**FILE REF:** RM150521  
**TO:** Blair Devlin – Manager, Planning Practice  
**FROM:** Rebecca Holden  
**DATE:** 23 December 2015  
**SUBJECT:** **Requirement to hold a hearing pursuant to Section 100 of the Resource Management Act 1991 (RMA).**

## DECISIONS OF THE QUEENSTOWN LAKES DISTRICT COUNCIL

<b>Applicant:</b>	S McMaster and Winestock Trustees Limited
<b>RM reference:</b>	RM150521
<b>Application:</b>	<p>Application under Section 88 of the Resource Management Act 1991 (RMA) for a subdivision consent to create three lots and identification of residential building platforms on each.</p> <p>Application under Section 88 of the Resource Management Act 1991 (RMA) for a land use consent to construct a dwelling on one of the residential building platforms, to undertake associated earthworks, and to breach internal boundary setbacks.</p>
<b>Location:</b>	838 Lake Hawea – Albert Town Road, Hawea
<b>Legal Description:</b>	Lot 1 DP 300100 held on Computer Freehold Register 1399
<b>Zoning:</b>	Rural General
<b>Activity Status:</b>	<b>Discretionary Activity</b>
<b>Notification Decision:</b>	Publicly Notified
<b>Decision Date</b>	<b>15 February 2016</b>

**Figure 3: proposed Structural Landscape Plan for Lot 3**

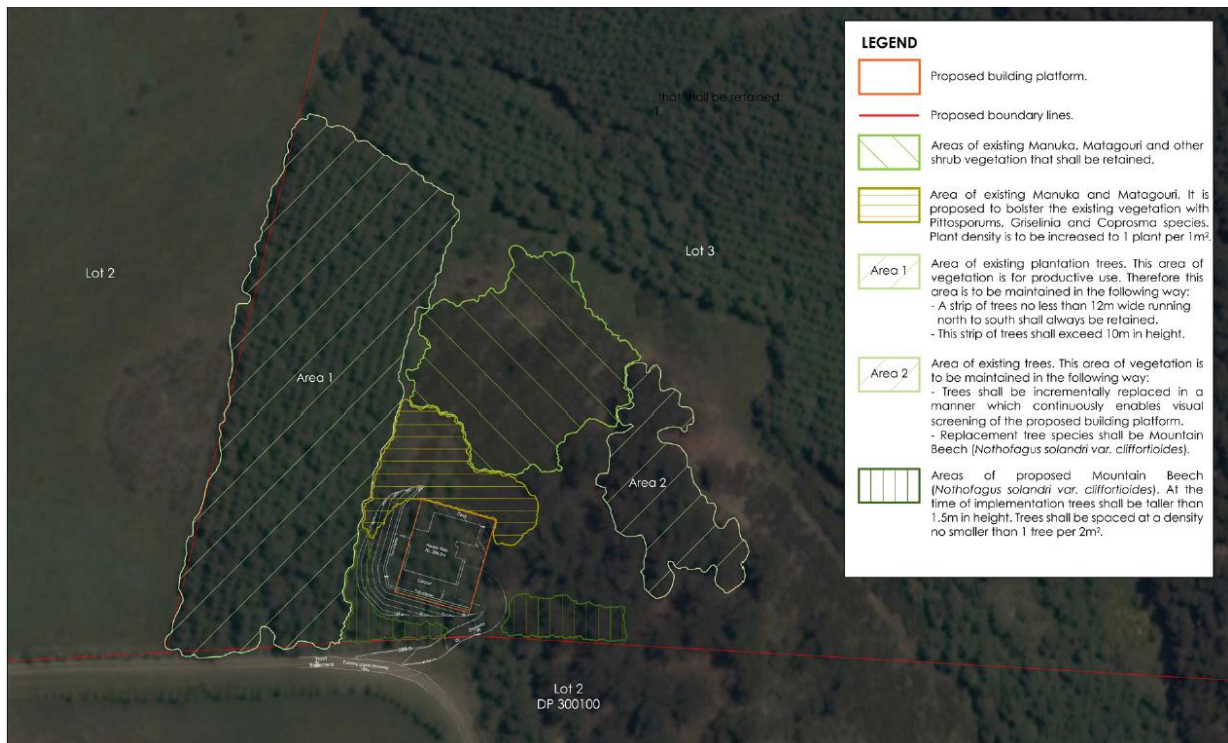
Ms Snodgrass recommends that the wording of the Structural Landscape Plan be modified to ensure that in Area 1 (as exists for Area 2); eventual tree replacement is by species such as Mountain Beech to ensure that long term mitigation against potential visual effects is achieved.
